Our ref: DOC22/256365-2
Your ref: SSD 12469087

Subject: Gunlake Quarry Continuation Project Response to Submissions

Attachment 1 - Outstanding biodiversity issues for the Gunlake Quarry Continuation Project

Figure 1 – Geological features included in the Holcim EIS for Lynwood Quarry, including faults and dykes (righthand pane), which are excluded from the Gunlake EIS groundwater model (lefthand pane).

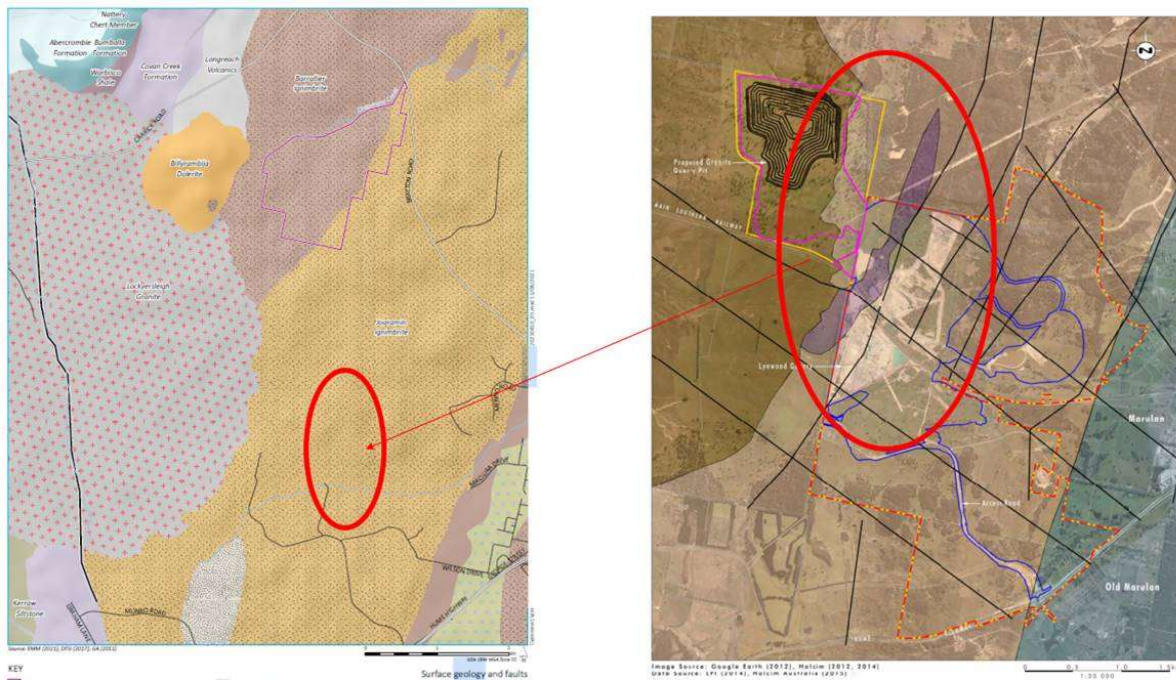
- The RTS has still not considered all available geological evidence which was included in the Holcim EIS for Lynwood Quarry (**see Figure 1**), such as faults and an adamellite dyke to the south and southeast of the pit (not to the south west, as stated in the RTS). It is noted that the groundwater modelling area for Gunlake Quarry includes the area of the dyke identified in the Holcim EIS (**see Figure 1, right panel**).

- It is still unclear why the groundwater model only shows drawdown occurring to the south of the pit.

- **Recommendation:** We agree with DPE Water's recommendation that the Applicant should improve the robustness of the impact predictions with a numerical groundwater flow model that is -

- calibrated and validated.
 - consistent with the Australian Groundwater Modelling Guidelines.
 - independently reviewed.
 - Due to the potential risks to an existing biodiversity offset site and a critically endangered ecological community, the independently reviewed groundwater model should be *prior to consent*.
